Advice received on hydrology, and in particular the chalk aquifer, 9/12/24

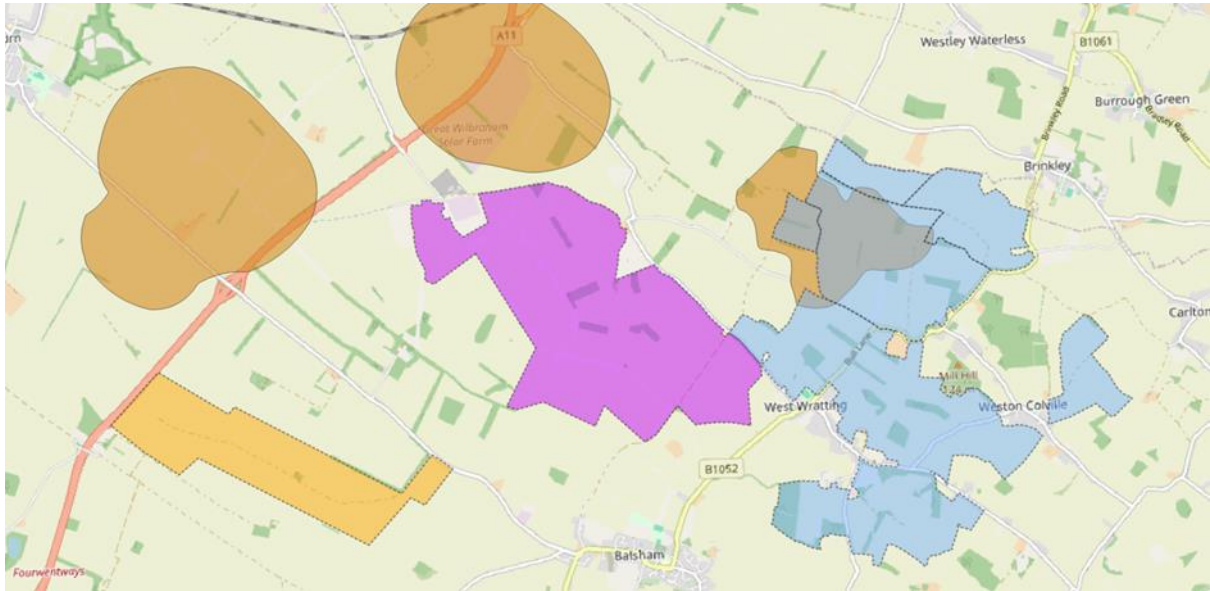
- As shown on https://kingswaysolarfarm.co.uk/wp-content/uploads/2024/10/P663900_Phase_One_consultation_environmental_constraints_A3L.pdf, there is a ground water inner source protection zone overlapping Site C and there is one just to the north of Site B. My version of the map is below.

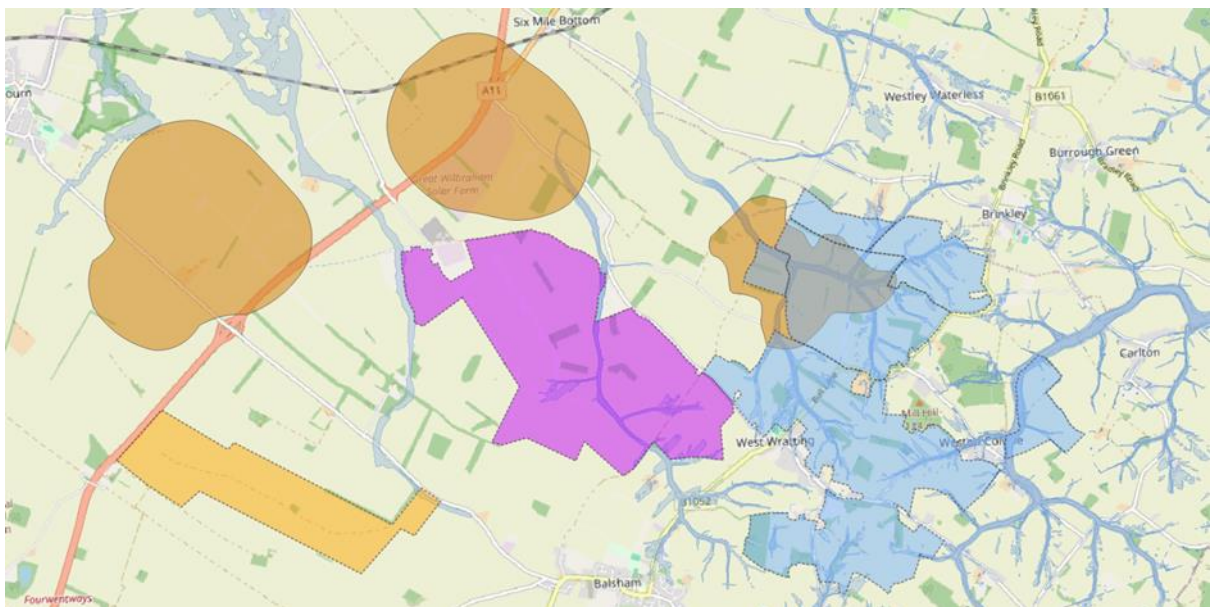
- Box 3.1 of the report at [Baseline report series. 5, the Chalk of the North Downs, Kent and east Surrey - NERC Open Research Archive](#) states that the Inner Source Protection Zone is designed to protect against toxic chemicals and waterborne disease.
- If you also look at the surface water maps, it's clear that the surface water from Site B and some of Site C passes through the inner source protection zones:
